September 2023
Former Nepera Plant Site, Harriman, New York

Phase II Emerging Contaminants Site Investigation Report Response to Comments and Associated Report Addendum

Re: Phase II Emerging Contaminants Site Investigation Report Response to Comments and Associated Report Addendum

Figure 1
Proposed Surface Water Sample Locations
Phase II Emerging Contaminants Site Investigation Report Response to Comments
Former Nepera Plant Site, Harriman, New York

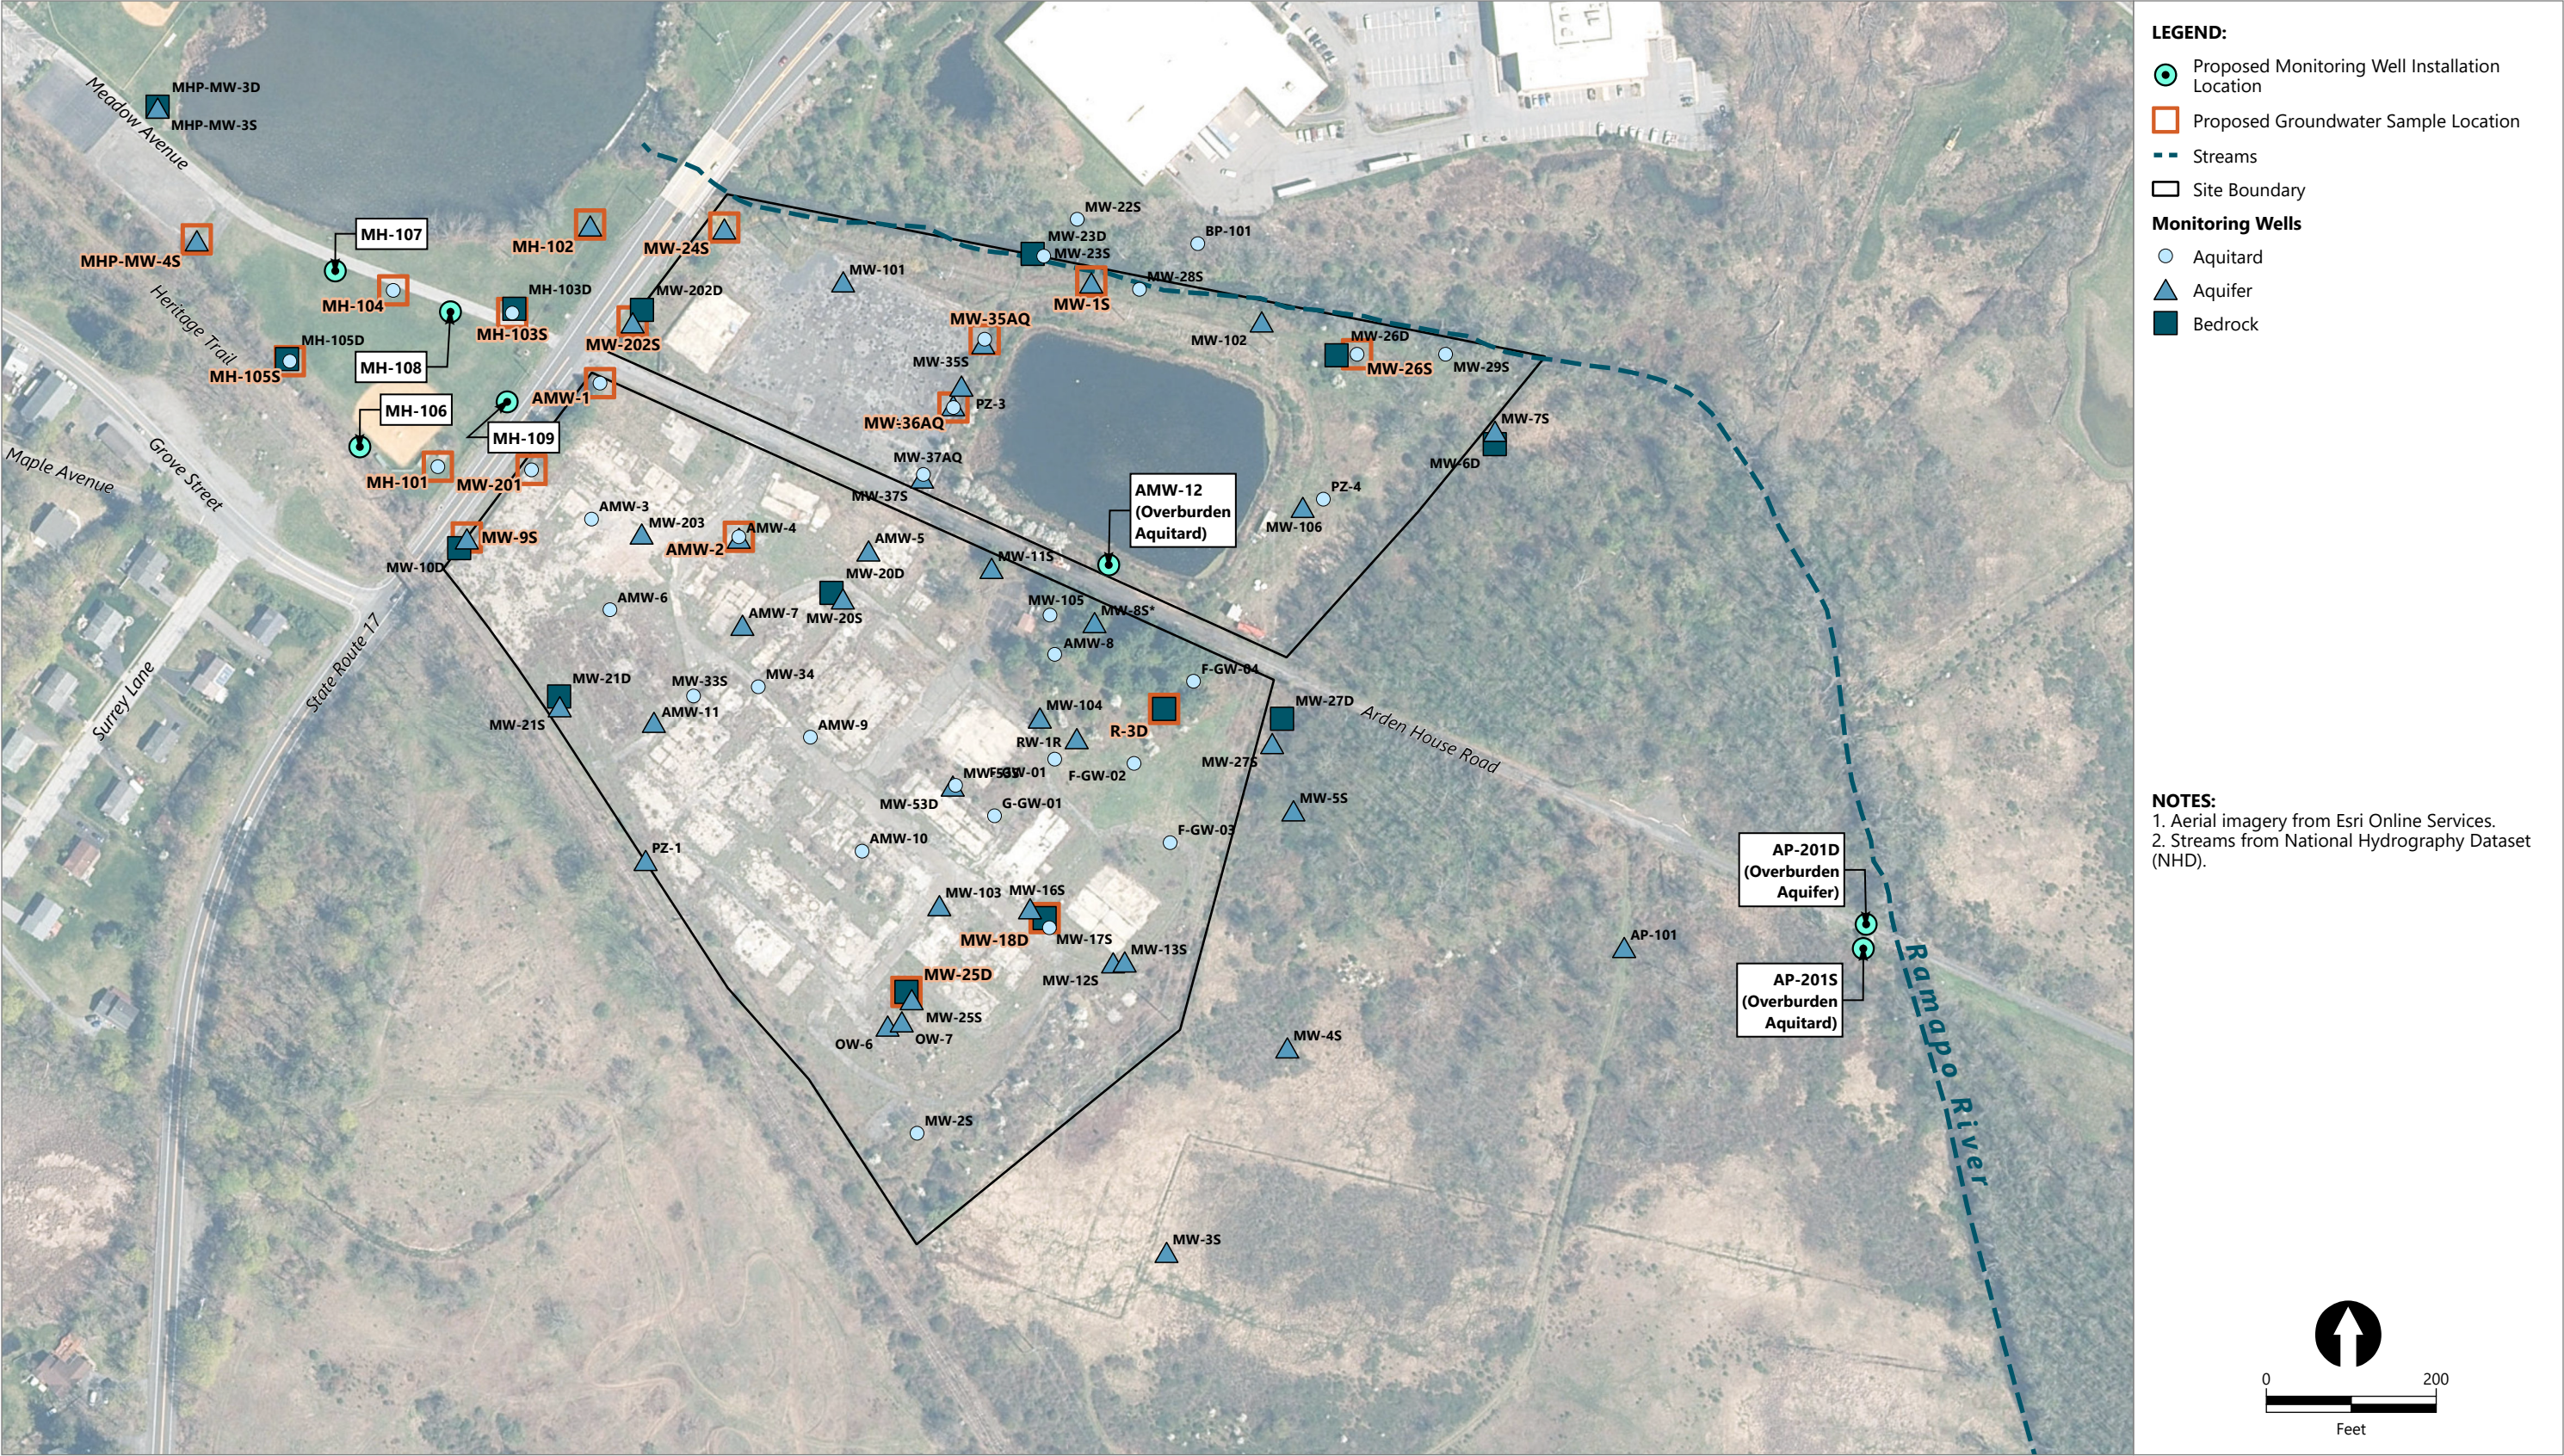
The locations of surface water samples SW+8.65S and SW+14S have been changed so they are adjacent to wells MW-1S and MW-26S, respectively. The change in location will mean that the IDs of the two points will be revised to SW+5.88 and SW+9.95, respectively. Please see Figure 1, attached to this memorandum, for revised proposed locations of surface water sampling. Figure 1 is a revision of Work Plan Addendum's Figure 5. The Corporate Defendants and ELT would like to note that reasonable effort will be made by the field team to collect a sample at the proposed location, but site conditions (e.g., dense vegetation, steep streambanks, isolated areas of deep water, or woody debris

The proposed surface water sampling points have not been amended to include a new location at the culvert outfall discharging from the Town of Harriman wastewater treatment plant. The Work Plan Addendum contains a sampling point, SW-0.90N, that the EC Report states is located on the "north side of the stream, north of NY Route 17 where the Harriman Sewage Treatment Plant discharges." This surface water sample will be collected as close to the outfall as is reasonably accessible.

in the river) may prevent access to the exact sampling point shown in Figure 1. In such instances, a sample will be collected from the closest accessible location if practicable.
